TECHNICAL BULLETIN JTB00370NAS1 05 AUG 2014

Condensation on Instrument Panel Center Vent

F-TYPE (X152)

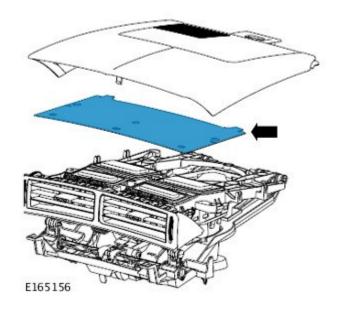
Situation: Condensation may be evident on the instrument panel center vent.

Cause: This may be caused by a difference in air/trim temperature, resulting in condensation forming on top of

the instrument panel center vent.

1. ANOTE: Removed for access only.

Remove the instrument panel center vent (see TOPIx Workshop Manual, section 412-01).

2. Install the foam pad to the center vent.

${f 3.}$ Install the instrument panel center vent (see TOPIx Workshop Manual, section 412-01). .
